Project 86-060-24  
December 1990

# Response to Comments and Proposed Reclamation Plan Modifications

Church Rock Site  
Gallup, New Mexico

United Nuclear Corporation  
Gallup, New Mexico

DATE: 11-13-90	FIGURE 2-3	DRAWING NUMBER
SCALE: AS SHOWN		86-060-E 427

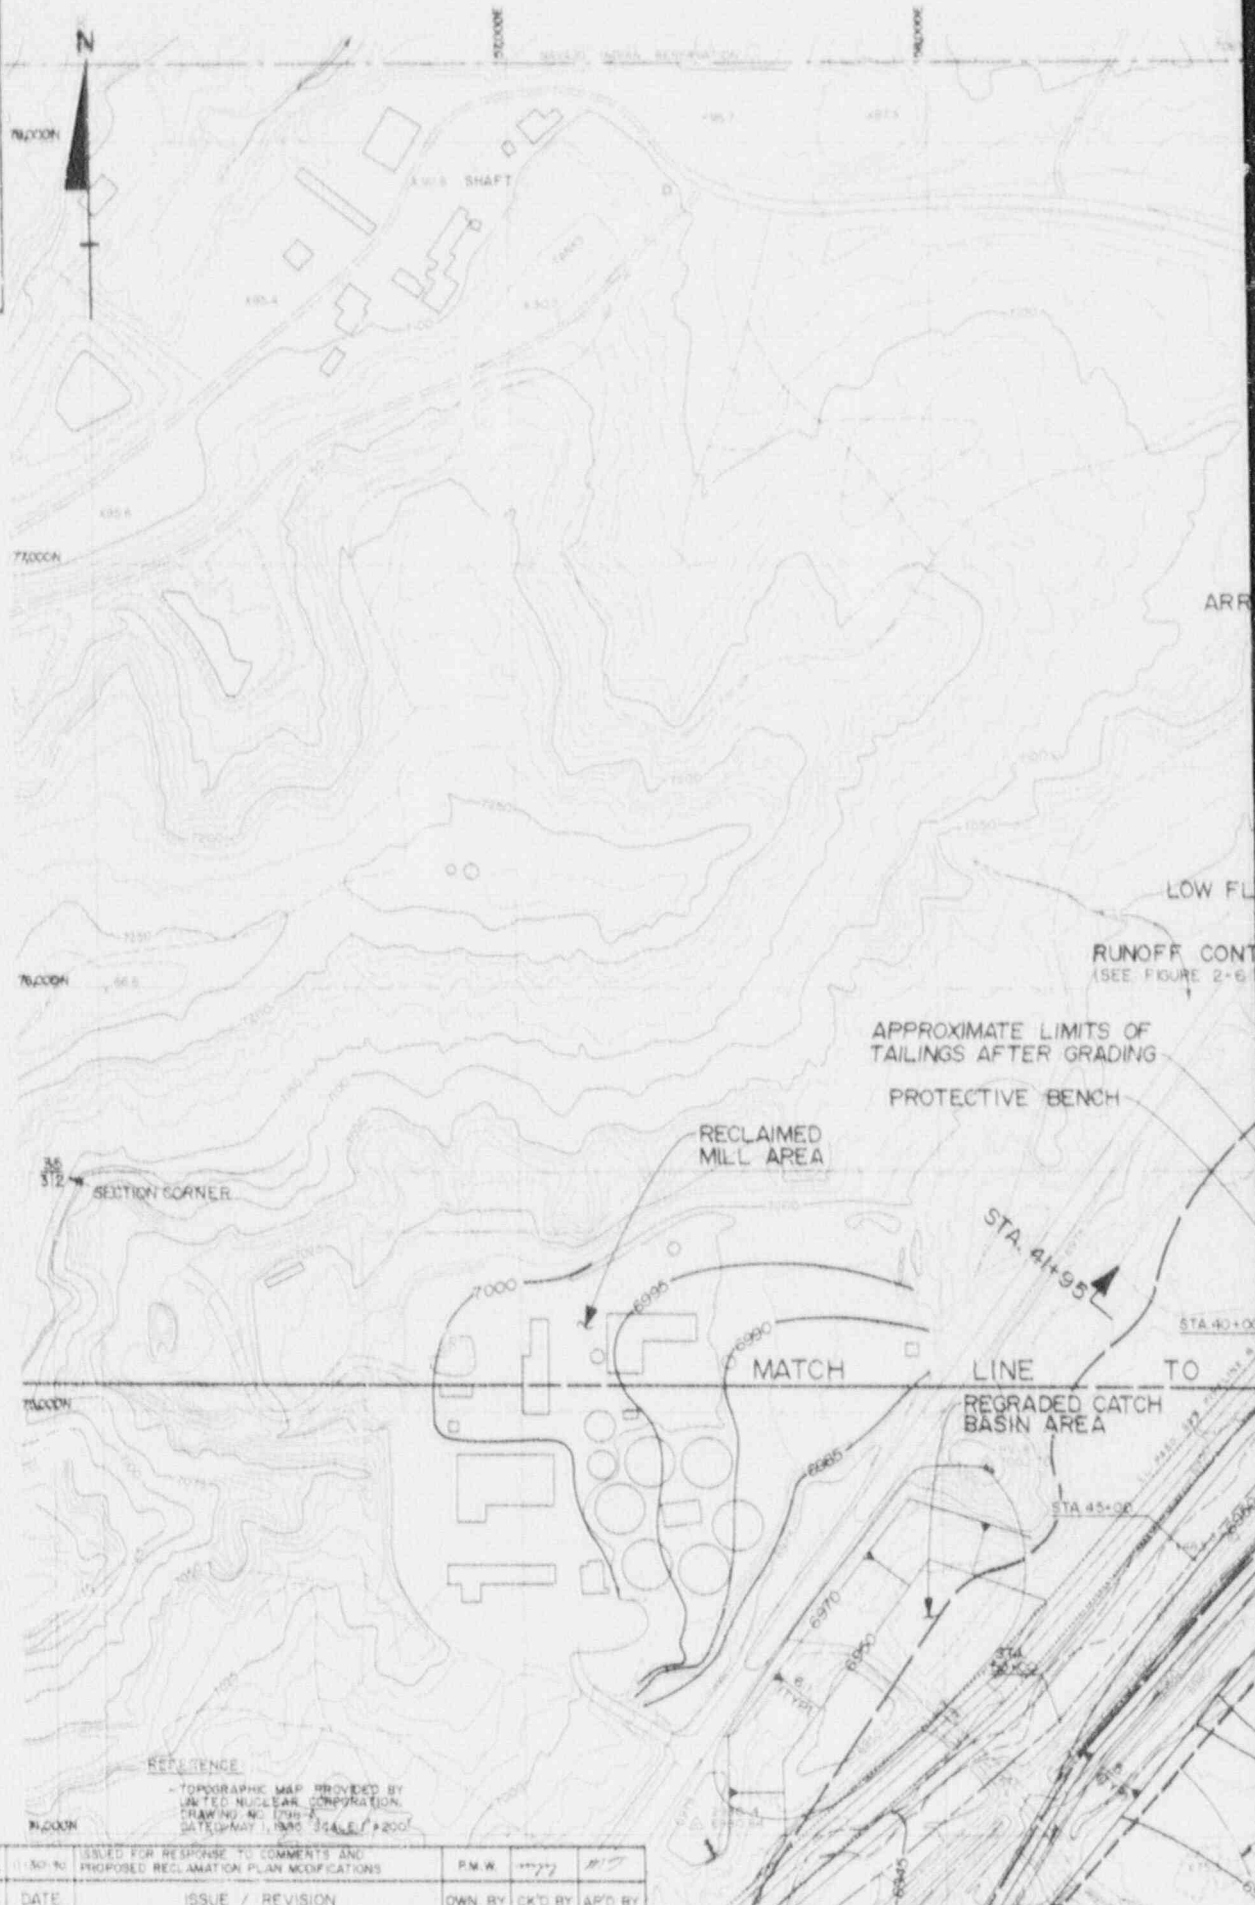
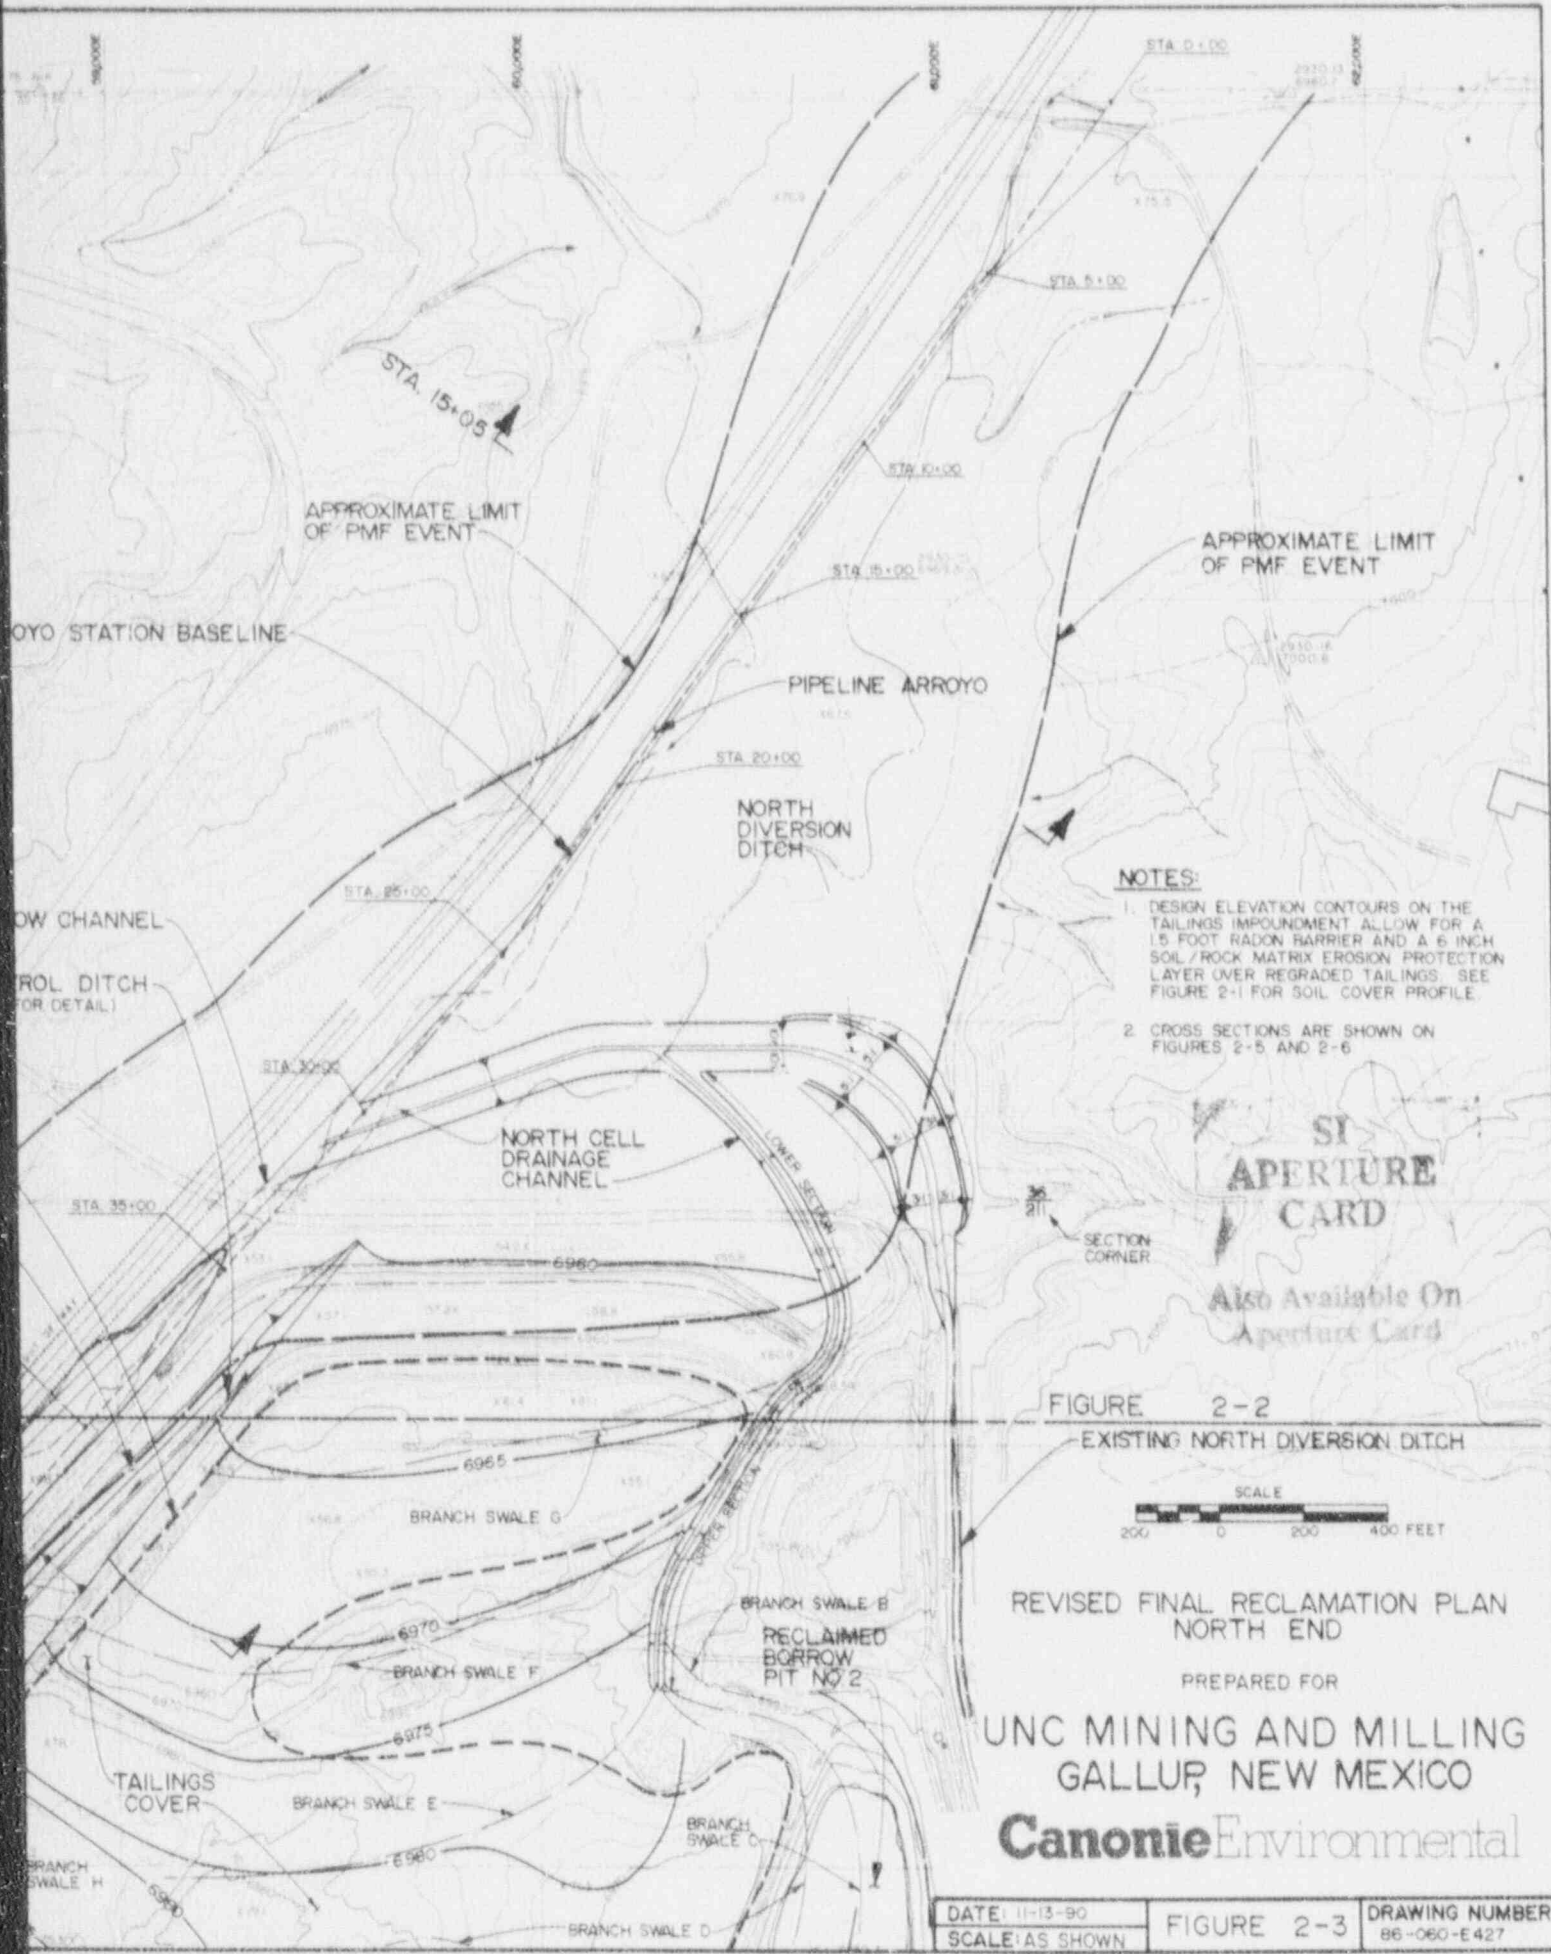
Figures 2-2 and 2-3 depict the proposed modified tailings impoundment configuration and grades at final reclamation. This configuration has been changed from that of the original reclamation plan (see Figure 1 of the August 31, 1988 responses to comments and Figure 3 of the September 12, 1990 response to comments) in three aspects. First, the surface contour elevations have been reduced 2 feet to reflect the resulting reduced tailings cover thickness. Second, additional swales have been added to the South Cell to collect surface water runoff. Third, the tailing's 2-foot soil cover will incorporate a 6-inch-thick soil/rock matrix to protect the cover from erosion. These proposed design modifications promote surface water drainage while maintaining the erosional stability of the tailings soil cover.

Figures 2-2 and 2-3 provide a plan view of the revised Pipeline Arroyo channel configuration at final reclamation. The channel will be modified only slightly from its present configuration to enhance its flow capacity

Figures 2-2 and 2-3 show the extent of the PMF floodplain, while Figure 2-4 shows the profile of the PMF maximum WSEL. The PMF fills most of the wide valley north of the tailings impoundments. The WSEL of the PMF stays below the top of the protective bench from station 35+00 to station 80+10. Downstream of station 63+90, the PMF is contained within the Pipeline Arroyo channel and does not reach the overbank area or the protective bench.

DATE: 11-9-90	FIGURE 2-4	DRAWING NUMBER 86-060-B420
SCALE: AS SHOWN

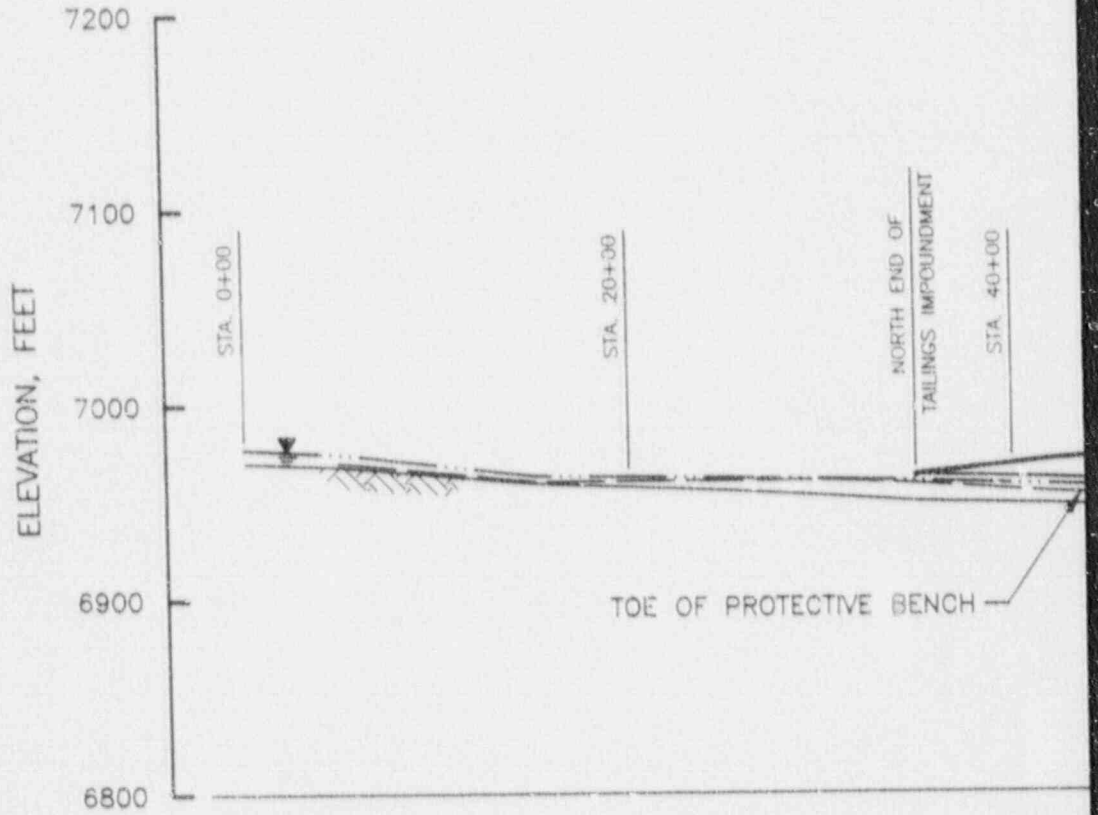
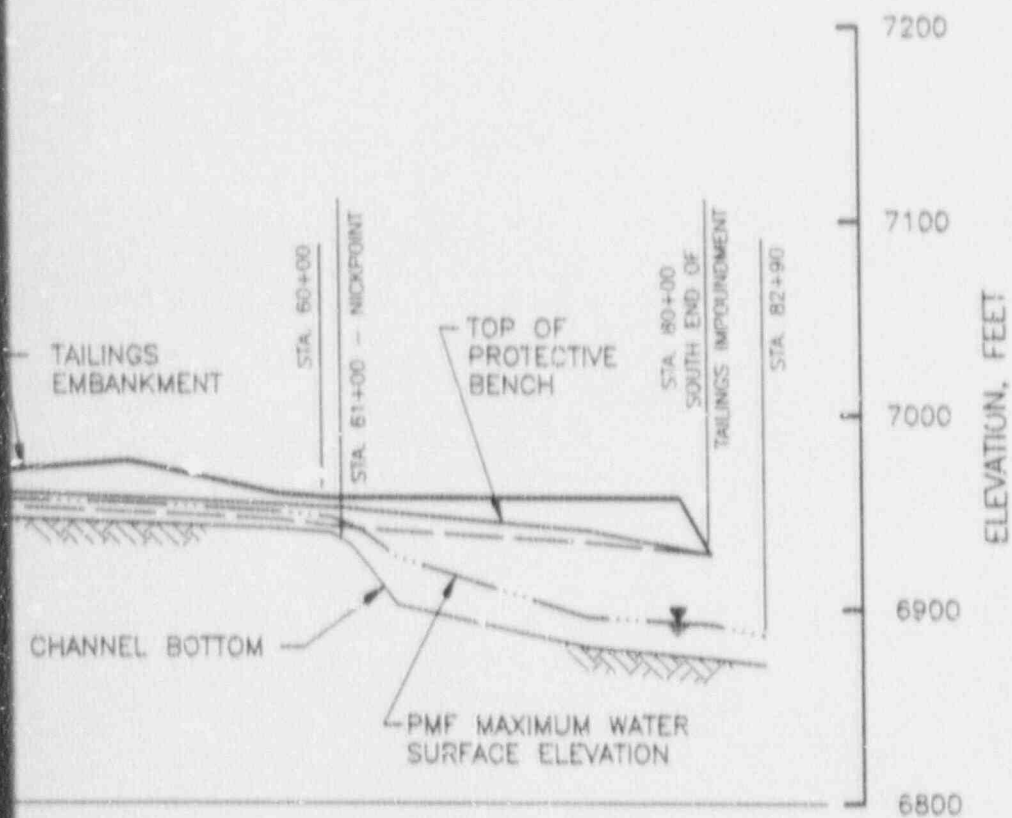
Figure 2-4 shows that the PMF water surface elevation is less than that of the top of the proposed protective bench. Thus, the bench would protect the embankment toe and would keep the runoff control ditch above the PMF level. The average velocities and depths of the PMF within Pipeline Arroyo along the 5H:1V sideslopes of the protective bench were determined by the HEC-2 program and are summarized below:

Figure 2-4 provides profiles of the channel bottom, PMF water surface elevation (WSEL), protective bench toe, protective bench top, and tailings embankment top from station 0+00 to station 82+90. The profile shows the shallow slopes of the Pipeline Arroyo channel bottom upstream from the nickpoint and the spatial relationship of these features.

DATE: 11-12-90	FIGURE 2-5	DRAWING NUMBER
SCALE: AS SHOWN		86-060-8424

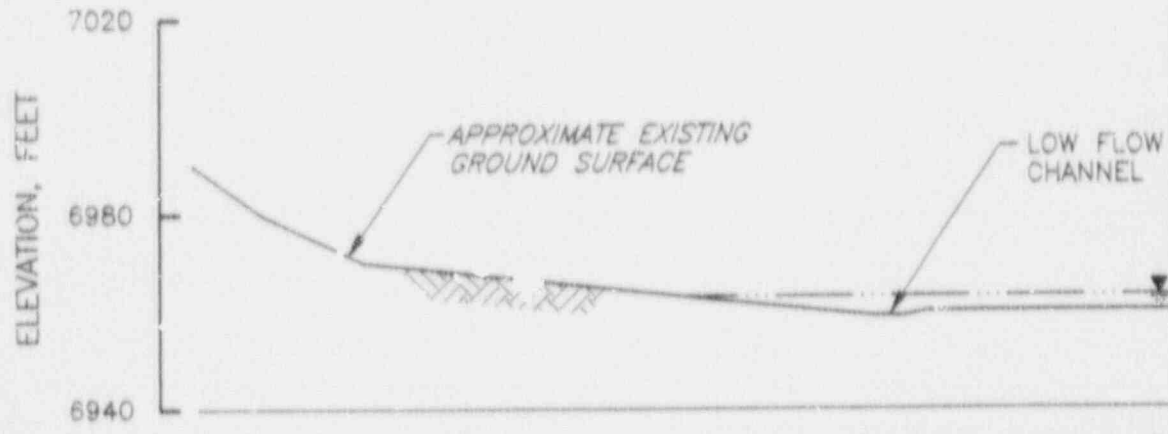
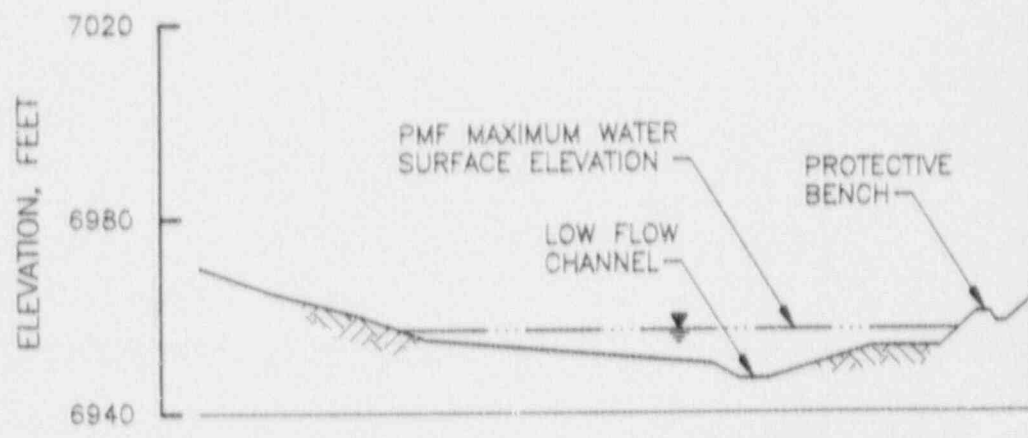
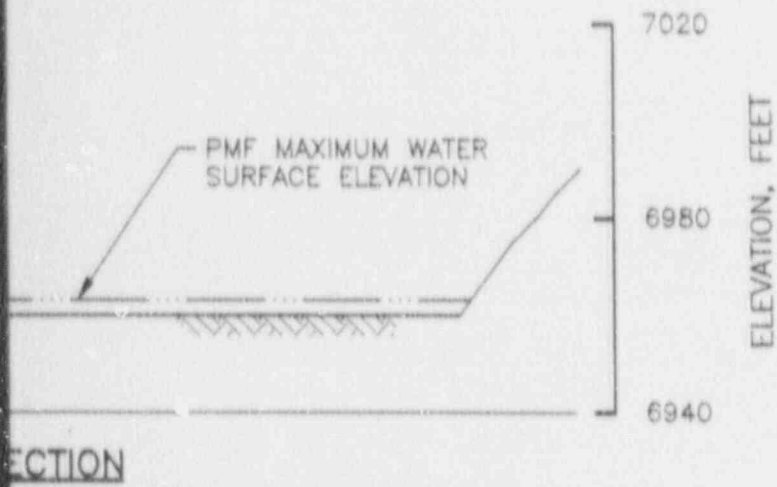
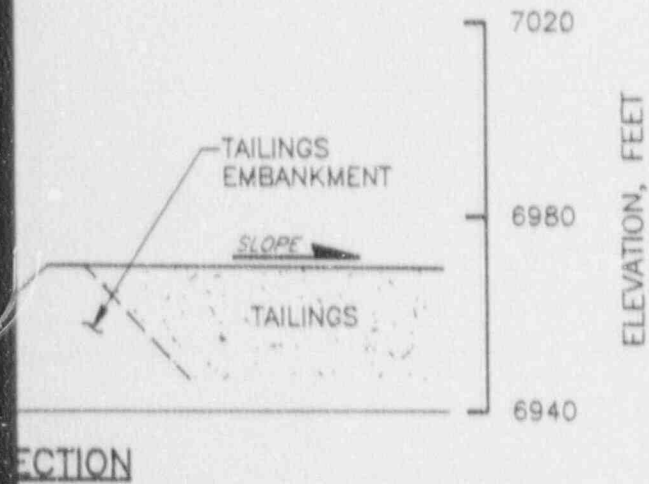
Figures 2-5 and 2-6 provide several cross sections across Pipeline Arroyo to the reclaimed tailings embankment top. These cross sections also illustrate the spatial relationships between the channel, bench, and embankment.
